## STATEMENT OF COMMONALITY V6

**FOR THE DEVELOPMENT CONSENT ORDER  
APPLICATION FOR THE ALTERATION AND  
CONSTRUCTION OF HAZARDOUS WASTE AND LOW  
LEVEL RADIOACTIVE WASTE FACILITIES AT THE EAST  
NORTHANTS RESOURCE MANAGEMENT FACILITY,  
STAMFORD ROAD, NORTHAMPTONSHIRE**

**PINS document reference: 9.3**

**Report Reference: AU/KCW/LZH/1724/01/SOCGST/V6**

**Figure 1:** Original contour lines in currently permitted restoration plan

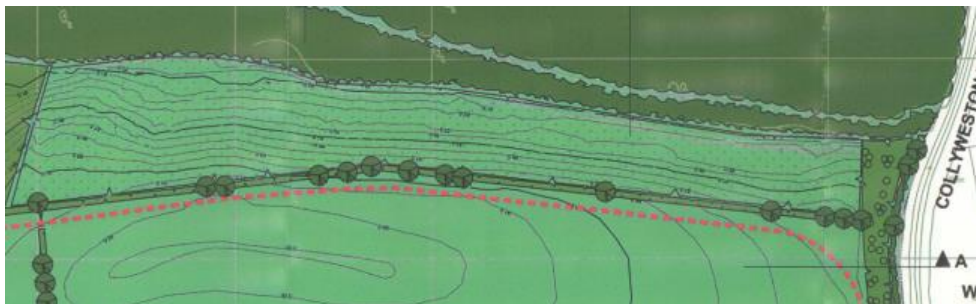
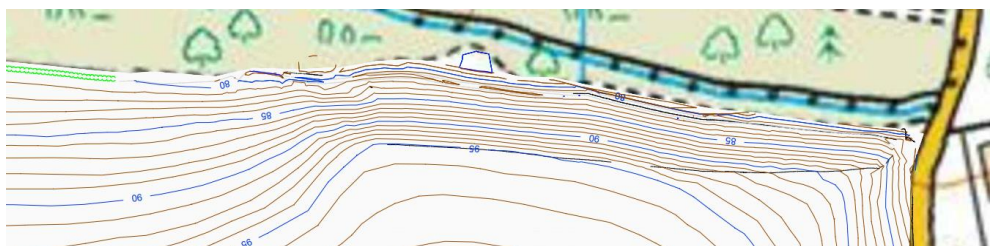
As you are aware we have raised our concerns regarding the long term structural stability of unsettled land form (in figure 2). As you explained this afternoon, the land profile in figure 2 is of an approximate gradient of 1 in 2 and reflects the landform in existence on site today. You have explained the landform shown in Figure 1 is that which was approved by the Environment Agency as part of your 2012 application and shows the settled landform.

Our client's previously stated concerns of the near "cliff edge" gradient and its proximity to our client's boundary and the long term structural stability of this landform; remains of concern to our clients, and further assurance on long term structural stability of this land form especially in periods of high and prolonged rainfall would be welcomed. We note the surface water drainage proposals for this specific area rely on existing open surface drains cut into the land form draining west into the attenuation pond.

**Figure 2:** Proposed contour lines

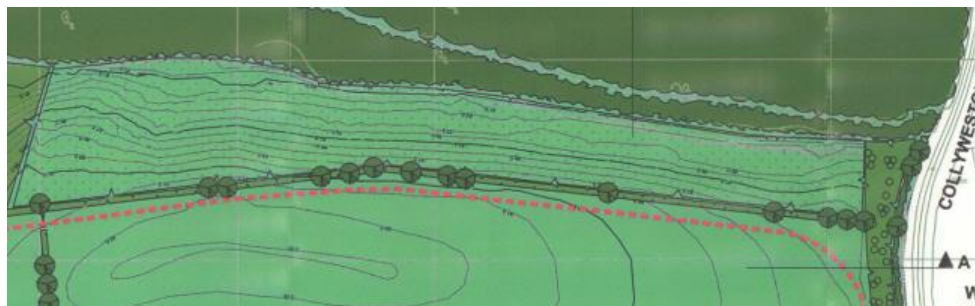
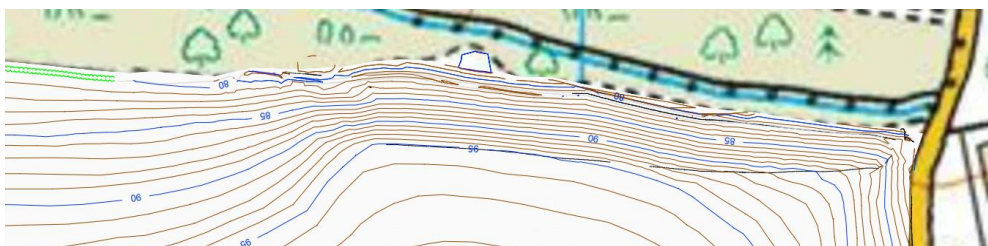
Thank you for confirming that Figure 1 below depicts the forecast settled restoration profile of the current land form consented under the existing consent for the site.

We note Figure 2 depicts the unsettled re-profiled landform proposed within your draft DCO application.

- a) The height of top of the current unsettled landform shown in figure 1
- b) The height of top of the proposed unsettled landform shown in figure 2
- a) The height of top of the proposed landform shown in figure 2, when settled and confirmation as to when it will reach its settled state.
- b) The engineering drawings and calculations prepared to demonstrate the continual stability of the extremely steep re-profiled slope shown in figure 2
- c) We note during our call on 6<sup>th</sup> April, you were coming forward with details of how you will capture water runoff from this section of the landform to prevent it discharging onto our client's land. We look forward to receiving this from you.

**Figure 1:** Original contour lines in currently permitted restoration plan

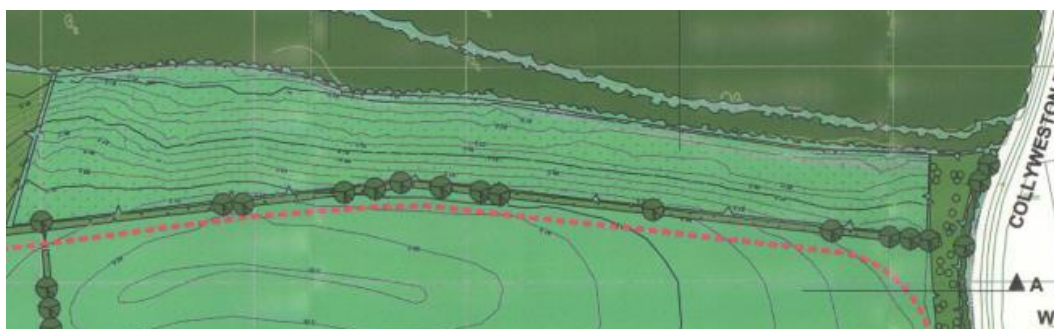
You have stated that there will be very little increase in the maximum height of the waste and that the northern slope at section C-C will not change as a result of the current proposals. However, when comparing the original contour lines in the currently permitted restoration plan with the latest restoration plans that now incorporate the western extension, it is immediately apparent that the proposal is that the gradient is steepened.
